Response to the CSELR Planning Modification Report (SSI-6042)

City of Sydney
Town Hall House
456 Kent Street
Sydney NSW 2000

December 2014

Figure 3.3 Proposed modification to the Grosvenor Street stop

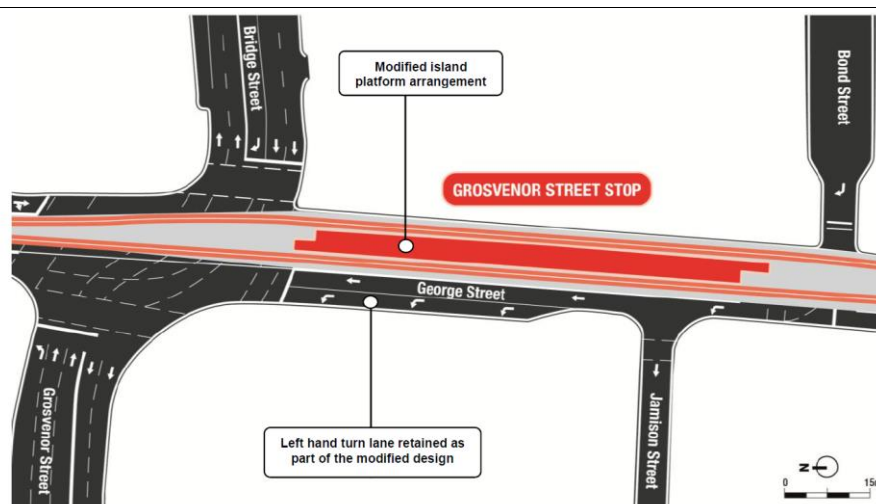
Proposed Modification	City's Response
Grosvenor St Stop arrangement	<p>The proposed platform arrangement for the Grosvenor St stop has changed from a central track running and two side platforms to an off-set north and south central platform. The proposal also provides for a new left hand turn lane off George St into Grosvenor St, which precludes wider eastern and western footpaths as in the approved proposal.</p> <p>Traffic access on George Street to travel north in this block will only be right from Bond Street or left turn from Margaret Street. This was the arrangement in the original proposal with only one north bound lane to cater for traffic flow.</p> <p>There has been no change since the Infrastructure Approval that would generate additional northbound traffic and the City considers that a single northbound lane only is necessary.</p> <p>In addition, a single northbound lane in George Street will better provide for pedestrians as the crossing will be shorter and the eastern and western footpaths can be widened.</p>

The new arrangement does not provide the following:

- Reduced functionality of the stop, as there will be no direct passenger access to the platform from the eastern footpath, which will be subject to the highest passenger load (in the PM peak);
- No additional footpath width for eastern and western footpaths;

The City's preference is to maintain a side platform arrangement wherever possible for overall network consistency and wayfinding legibility and to reinforce the view corridor that already exists along George Street. The City is also concerned that the island platform does not allow for future proofing of a larger pedestrian environment.

In addition, footpath widths must not be reduced below the widths specified in Clause 1.6.9 of Schedule 7 - Technical Requirements of the Development Agreement that TfNSW has entered into with the City of Sydney.

RECOMMENDATION 3:

Delete proposed left hand turn from George St to Grosvenor St;

Revert to previously approved side platform arrangement;

Widen eastern and western footpaths on George St as previously approved;

Comply with minimum paving widths as per Clause 1.6.9 of Schedule 7 - Technical Requirements of the Development Agreement.

Additional footpath width in George Street.

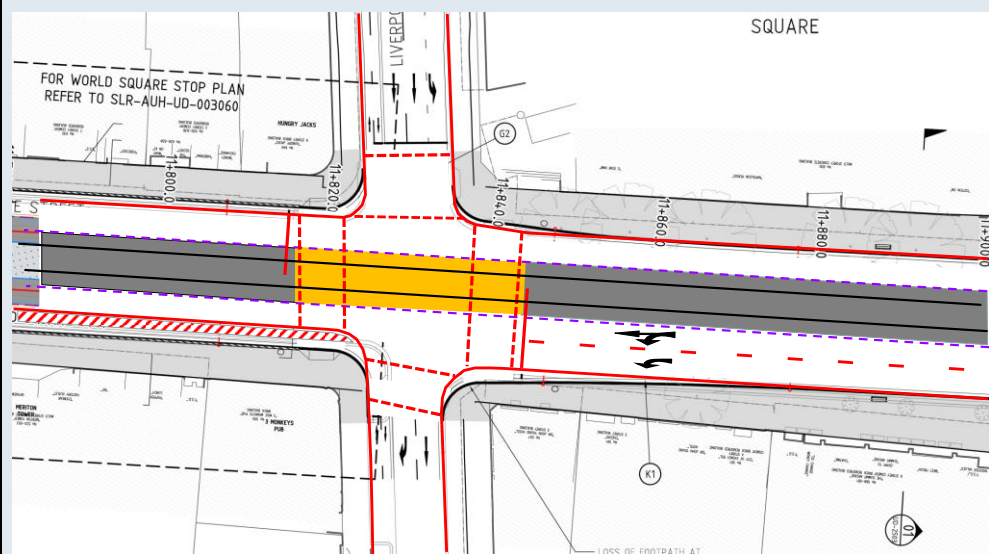
The City supports removal of the World Square platform provided footpaths on the eastern and western sides of George Street from Liverpool Street to Bathurst Street are widened.

Below shows the possible footpath improvements (in red) that the City is seeking to be included as conditions following the elimination of the World Square stop, in addition to the proposed widening along both sides of George St between Wilmot and Bathurst Sts.

Additional footpath width (retains south/west corner alignment and reduced pedestrian crossing distance).

Widen pavements as shown in above sketches, in addition to the proposed widening along both sides of George St between Wilmot and Bathurst Sts.

**View south along
Bus Roadway**

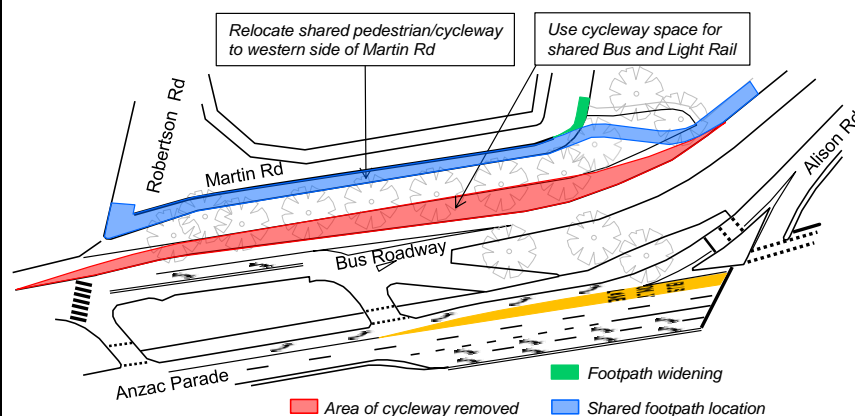
Tay Reserve is not realistic given the highly negative impact caused by the removal of trees near Martin Rd and Robertson Rd.

The City considers that the design from the shared section of the bus and light rail corridor south of Robertson Road and around to Alison Road must be reconsidered to have no or less impact on the trees.

If the design cannot accommodate bus roadway, light rail and shared pedestrian/cycleway path without impact on the trees, then an option would be to relocate the pedestrian/cycleway path to the western side of Martin Rd. This will allow the use of the additional pedestrian/cycleway space as part of the shared section of bus and light rail.

There would be a loss of parking which can be recovered by introducing some angle parking in the wider sections of Robertson and Martin Roads.

Redesign the shared section of the bus and light rail corridor south of Robertson Road and around to Alison Road to have no or less impact on the trees, investigating the option to relocate the pedestrian/cycleway path to the western side of Martin Road;

Figure 5.1d (Extract) - Key features of the CSELR proposal, page 5-5, EIS Volume 1A

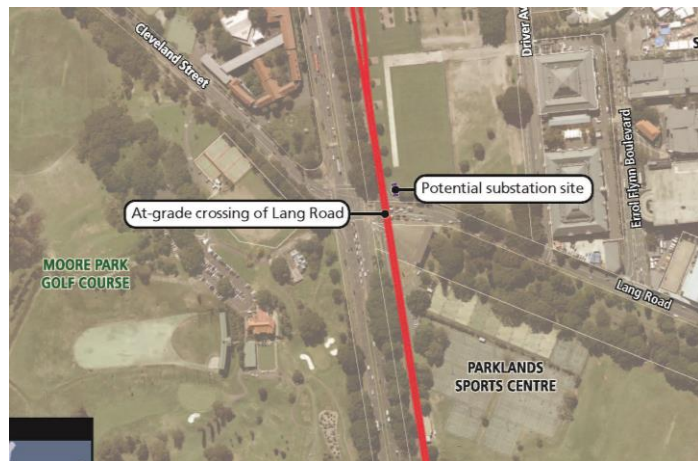
Revised substation sites	<p>The City supports the proposed relocation of the Surry Hills substation from the new Wimbo Park to be underground within the western portal of the Moore Park tunnel.</p> <p>However no clarification has been given about the final location of the Moore Park East substation. The project's Environmental Impact Statement identified the location of a substation on Moore Park East on the north eastern corner of Lang Road and Anzac</p>

Parade as per extracted figure 5.1b below:

Figure 6.2d (Extract) - Key features of the revised CSELR proposal, page 6-6, Submissions Report Volume 1

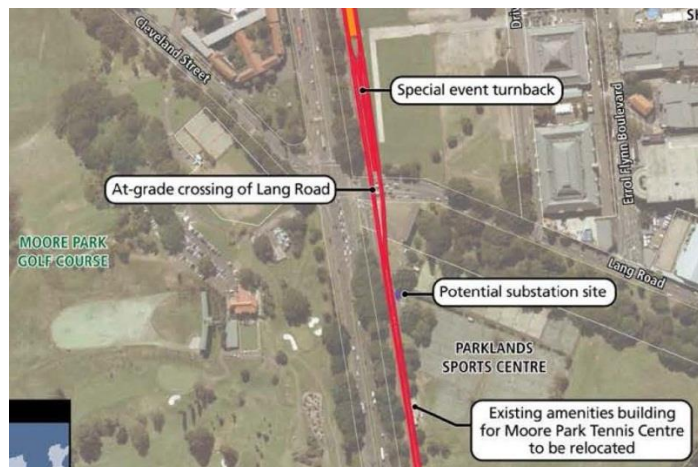
Table 4.2 of the Submissions Report, Volume 1 on page 4-9 stated: “Preference for below ground substation at Moore Park or integration with new amenities building near tennis centre”, with Figure 6.2d (image below) of the same volume of the Submissions Report, on page 6-6 showing the proposed substation on the southern side of the intersection of Lang Road and Anzac Parade. This is contradictory as the image shows one location and yet the table gives two options.

Given above City considers that no location has been approved for the Moore Park East substation given.

<p>Figure A - City of Sydney's Stormwater Drainage System at Moore Park between Lang Road and Roberston Road – grey shows area potentially impacted by any above-ground substation</p> <p>If the proposed substation is constructed next to the new amenities building, it would be located over this stormwater drainage box culvert. The box culvert could be reaching its life expectancy and it was not design to accommodate the load that the substation would transfer to it. This could have serious consequences for its structural integrity, affecting the new substation, making future maintenance and repair operations difficult and significantly more expensive for the City.</p> <p>The City of Sydney opposes the construction of the substation near the amenities building and recommends the construction of the underground substation near the southern side of the intersection of Lang Road and Anzac Parade as presented in Figure 6.2d of the Submissions Report Volume 1 (above).</p> <p>RECOMMENDATION 11: That the Moore Park East Substation be located near the southern side of the intersection of Lang Road and Anzac Parade as presented in Figure 6.2d of the Submissions Report Volume 1.</p>

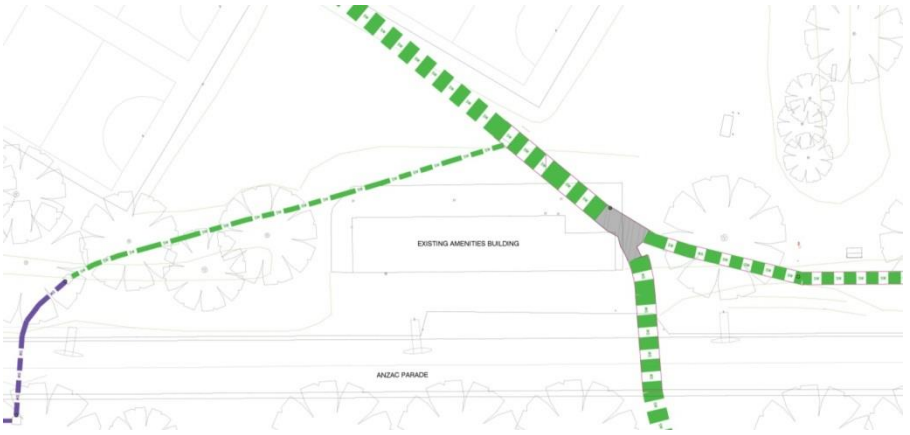
The City of Sydney Council has a large stormwater box culvert running near the existing amenities building, refer to figure A below. The existing records show that the 2.4 x 1.1m box culvert was constructed before 1920, hence it is potentially a 94 year old asset.

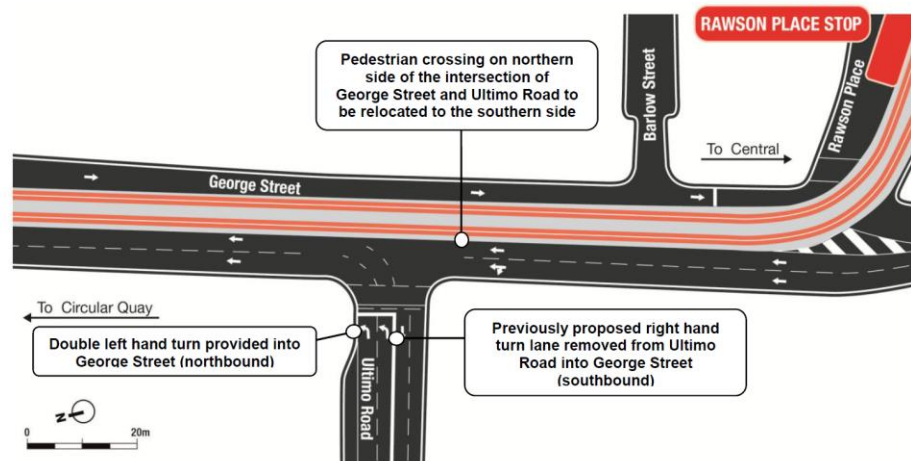
<p>Additional issues the City wishes to raise</p>
<p>George St/Ultimo Rd intersection</p>	<p>The proposed relocation of the pedestrian crossing in George Street from the northern side of Ultimo Road to south of Ultimo Road will maintain pedestrian access. The modified design bans the right turn from Ultimo Road to George Street (East to south) which will restrict local access and divert traffic to Harris Street via Ultimo Road. The City has no objection to this.</p>

However, the Harris Street and Ultimo Road intersection is already heavily congested especially in the evening peak period. In addition, it is expected there will be additional traffic on Sussex Street heading to Harris Street via Ultimo Road. The change to restrict the right turn to George Street will add to the congestion at the intersection of Harris St and Ultimo Rd.

An option to relieve the congestion would be to relocate the existing pedestrian signals in George Street near Valentine Street to the intersection of Valentine Street.

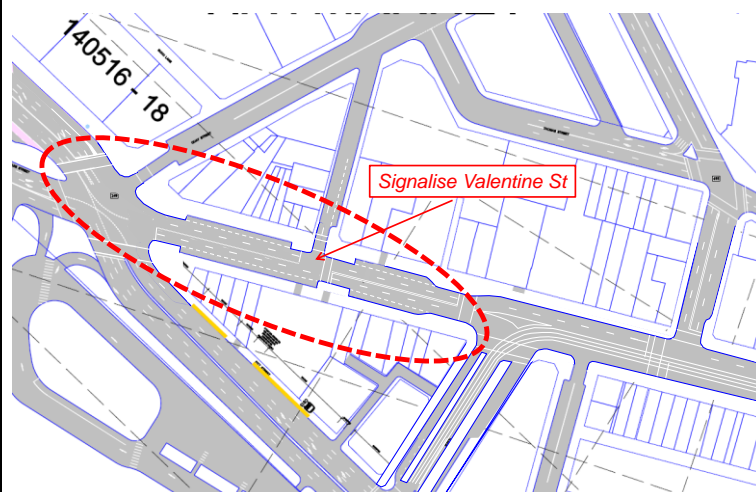
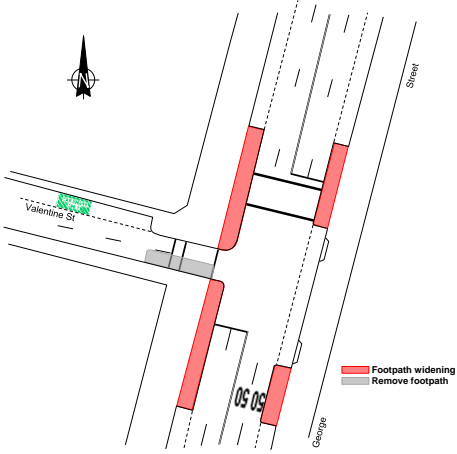
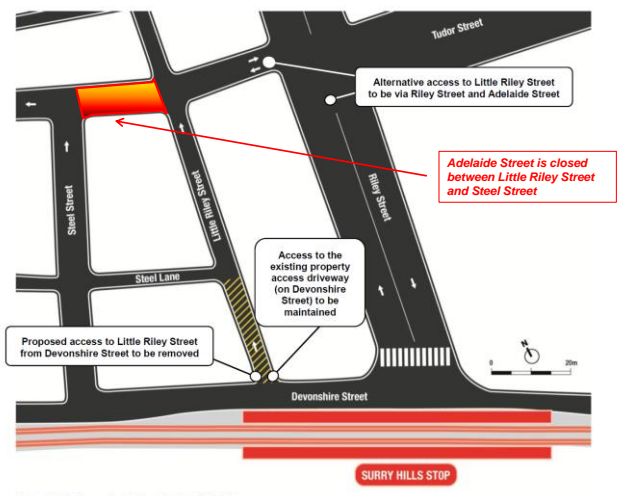
The concept sketches below illustrate footpath widening and possible traffic signal changes.

<p>Traffic signals to provide right turn from Valentine Street to George Street to travel south and east.</p> <p>RECOMMENDATION 12:</p> <p>Signalise Valentine St to allow a right hand turn to travel south along George St by relocating the existing pedestrian signals in George Street near Valentine Street to the intersection of Valentine Street;</p> <p>Undertake footpath widening at the George Street/Valentine Street intersection.</p>
<p>Little Riley Street, Surry Hills – Road Closure</p>	<p>The road closure of Little Riley Street will have an impact on the access to a short section of Little Riley Street, however the City has confirmed that this will not impact garbage collection.</p> <p>Currently Adelaide Street is closed between Little Riley Street and Steel Street, however this is not shown in the Modifications Report. It should be noted that residents have previously opposed re-opening of this section of Adelaide St and will oppose any proposed reopening.</p>  <p>Note: Indicative only. Subject to detailed design.</p> <p>Figure 3.8 Indicative arrangement for the Devonshire Street/Little Riley Street intersection</p>
